## Access Compliance Report Public Rights-of-Way (Curb Ramps)

Intersection ID: 13197 Main Street: S\_MCDOWELL\_ST Cross Street: E\_4TH\_ST Location: S

ADA ID: 08EF2C0E0738 Ramp Type: Perp Initial Pass/Fail: Fail Overall Compliance: No Severity Score: 37.5

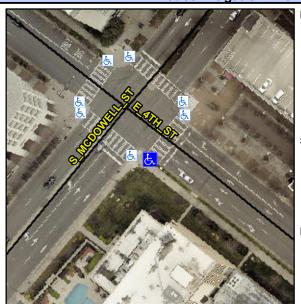
R304.2.2, R304.5.3

Field Measurements/Component Compnance							
Compliance Description Data			Comp	oliance Description	Data		
N/A	Ramp Length (in)	60.0	No	Ramp Slope (%)	9.0		
Yes	Ramp Width (in)	49.0	No	Ramp XSlope (%)	10.6		
N/A	Flare Type LT	N/A	N/A	Flare Type RT	N/A		
N/A	Flare Slope LT (%)	N/A	N/A	Flare Slope RT (%)	N/A		
N/A	Flare Traversable LT?	N/A	N/A	Flare Traversable RT?	N/A		
N/A	Landing Length (in)	N/A	N/A	DWS Provided?	N/A		
N/A	Landing Width (in)	N/A	N/A	DWS Contrast?	N/A		
N/A	Landing Slope (%)	N/A	N/A	DWS Length (in)	N/A		
N/A	Landing X Slope (%)	N/A	N/A	DWS Full Width?	N/A		
N/A	Landing Curb? (Y/N)	N/A	N/A	DWS Offset (in)	N/A		
N/A	Shared Landing?	N/A					
N/A	Gutter Ponding?	N/A	N/A	Gutter Slope (%)	N/A		
N/A	Gutter Lip Ht (in)	N/A	N/A	Gutter X Slope (%)	N/A		
N/A	Painted X Walk1?	Yes	N/A	Painted X Walk2?	N/A		
	X Walk 1 Direction	To NE		X Walk 2 Direction	N/A		
N/A	X Walk 1 Width (in)	181.0	N/A	X Walk 2 Width (in)	N/A

Remove & Replace Entire Ramp.
